APPLICATION NO.	FILING DATE	FIRST NAMED INVENTOR	ATTORNEY DOCKET NO.	CONFIRMATION NO.
10/633,554	08/05/2003	Hideo Shimada	1509.1036	6669
21171	7590	08/24/2004	EXAMINER	
STAAS & HALSEY LLP SUITE 700 1201 NEW YORK AVENUE, N.W. WASHINGTON, DC 20005			FIGUEROA, FELIX O	
			ART UNIT	PAPER NUMBER
			2833

Office Action Summary	Application No. 10/633,554	Applicant(s) UK SHIMADA, HIDEO	
	Examiner Felix O. Figueroa	Art Unit 2833

DETAILED ACTION

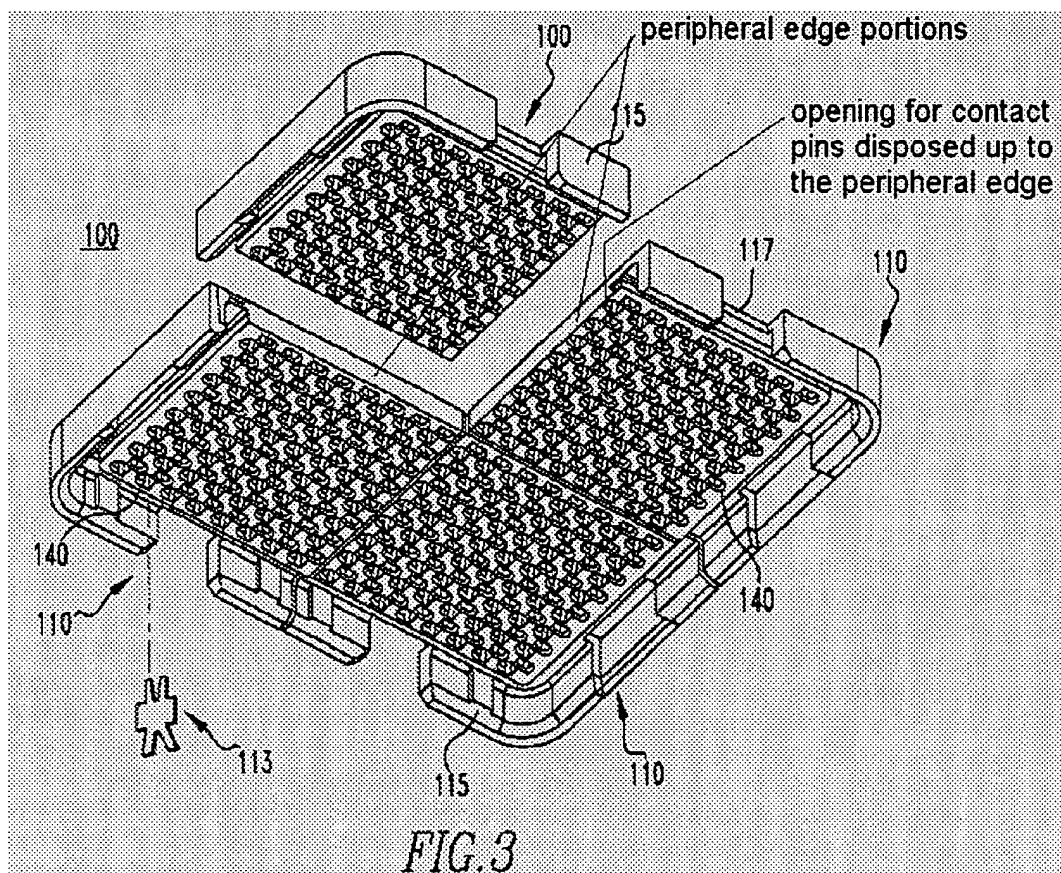
Regarding claim 3, Harper discloses a peripheral edge portion of the accommodating surface portion formed to be positioned at a place close to peripheral edge portion of the accommodating surface of another socket disposed next to the socket (see following figure).

Regarding claim 4, Harper discloses the contact pins being disposed up to the peripheral edge portions of the accommodating surface portion (see following figure).
